Access Compliance Report Public Rights-of-Way (Curb Ramps)

Main Street: REDBERRY_RD		Cross Street: EVENINGSIDE_DR		Location:	SW
ADA ID: RPRK220103123712	Ramp Type:Type 1 - Perpendicular Diagonal Initial Pass/Fail: Fail		Overall Compliance: No	Severity Score:	15
Codes/Mitigation Info/Possible Solution			Field Measurements/Component Compliance

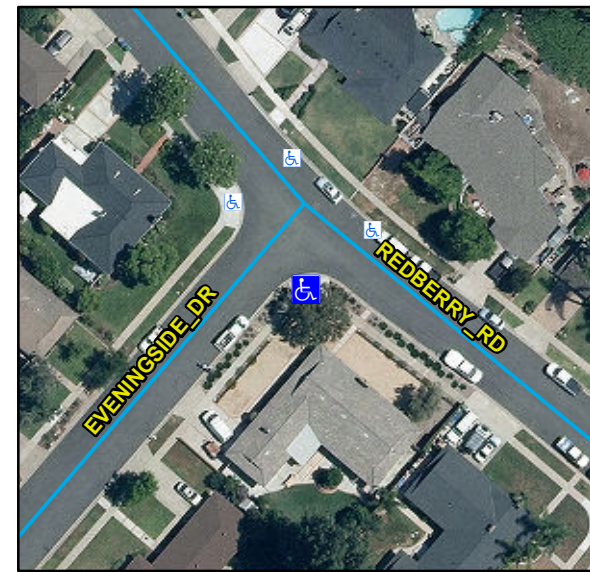
R304.2.2, STD 1115

Remove & Replace Curb Ramp With Two New Directional Ramps or Equivalent.
